# **MANDATORY SERVICE BULLETIN**

**Bulletin MSB-0001**

Issue Date 02/11/2011 Rev. -

Piper PA-31-350

FIGURE 1

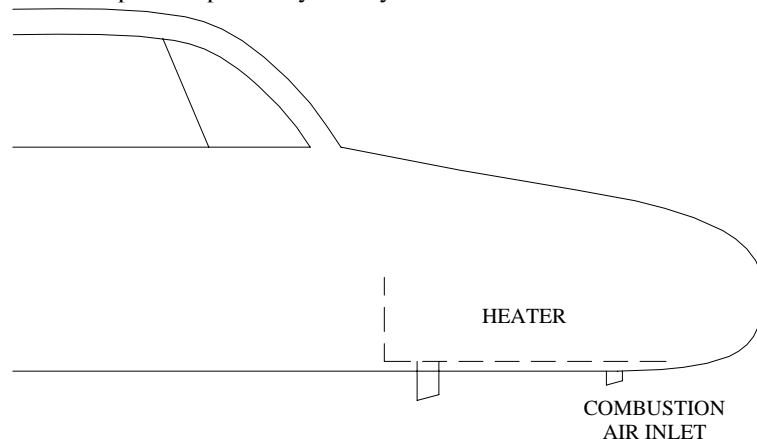
- i. Combustion air inlet modification (Step 2.A.)
    - ii. Fuel pressure check (Step 3.C.)
    - iii. Upper limit temperature setting (Step 3.C.2.)

1. Preparation:
  - A. Follow the Aircraft Service Manual or other FAA approved source for removal of the existing Combustion Heater.
  - B. Install the C&D Associates, Inc. TSO-C20 Approved Combustion Heater utilizing the existing Aircraft Service Manual or other FAA approved source where applicable.
2. Combustion Air Inlet Modification:
  - A. For proper combustion air balance, combustion air inlet scoop (located forward of where heater exhaust pipe extends out of aircraft.) needs proper scarf (see fig. 1). This angle is 15 deg. with longer portion of scarf aft. Supplied inlet template (fig 2) can be cut out and taped around existing inlet, transfer angle with a marker. Trim and de-bur. Top of template may or may not reach to aircraft skin.

**Figure 4**

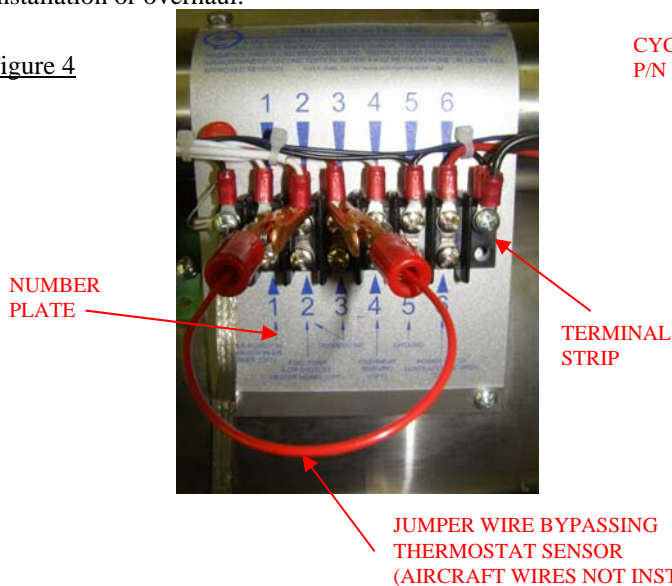
- B. Place a 6” 20G jumper wire with 2 small alligator clips (or the like) across the heater terminal strip numbers 2 and 3, which will bypass the aircraft thermostat. (Fig. 4)

- 1) With the heater running, verify fuel pressure. Preferred pressure is 8psi. (6.5psi min, 10psi max)
- 2) With the heater running, verify that the outlet plenum temp. is approx. 250°. Adjust the cycling switch if needed. Clock-wise to increase, counter-clock-wise to decrease temperature. (Fig. 5)
